SITE INSPECTION SHEET

OWNER: Tierney Ahearn PHONE #: _____
ADDRESS: 15280 Sweetbay St CONTRACTOR: _____
Woodbine MD WELL TAG #: HO-95-0633
SUBDIVISION: Belle Haven LOT: 25 COUNTY #: 13
PROPOSAL: Sinking patches continue to appear in yard especially
after heavy rains

LOCATION DIAGRAM

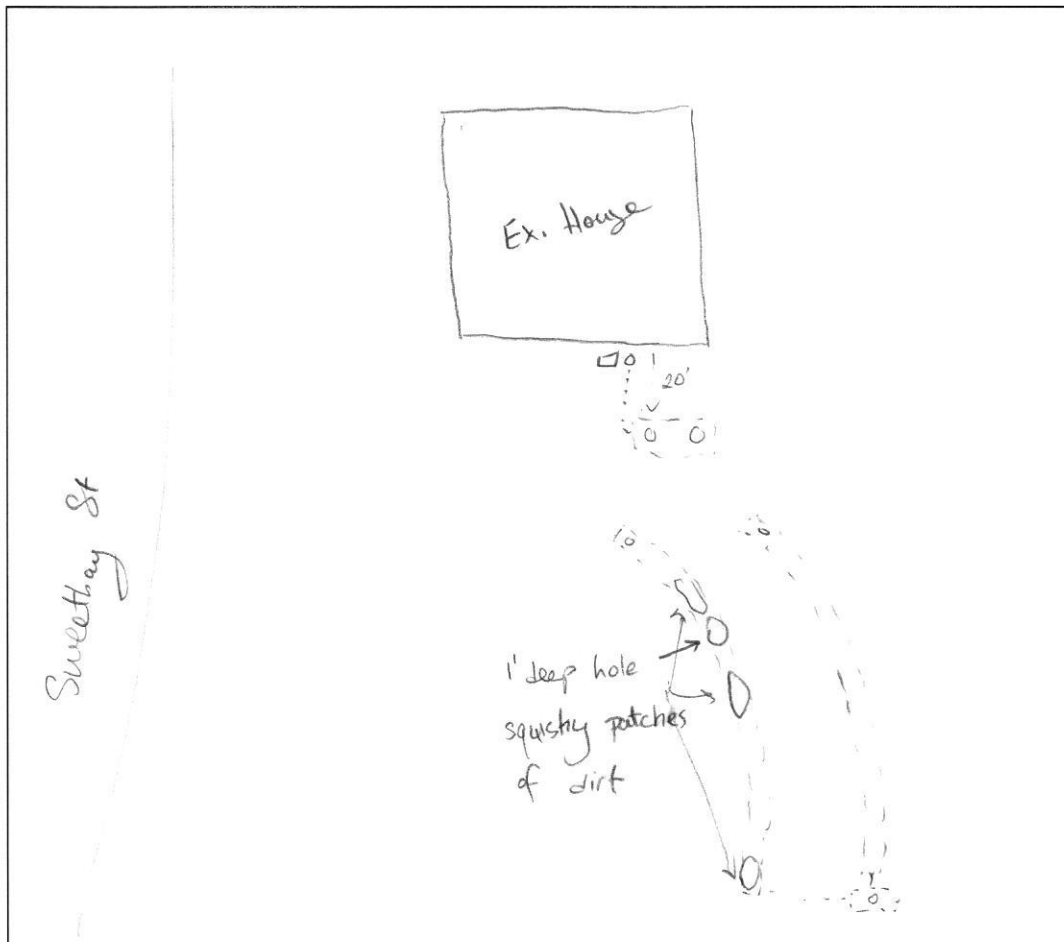
COMMENTS: Large patches of squishy soil along end of second trench. One
patch has 1'x1'x0.5' hole. Observation pipe of second trench has water
at the very bottom, first trench obs. pipe was dry. Lid of tank broken -
water level normal, HOOT observed to function. Mike Sample reports
HOOT last inspected on 4/16/21.

9/2/21 spoke with owner and advised that patches are most
likely result of landscaping. No sign of system failure (SR)
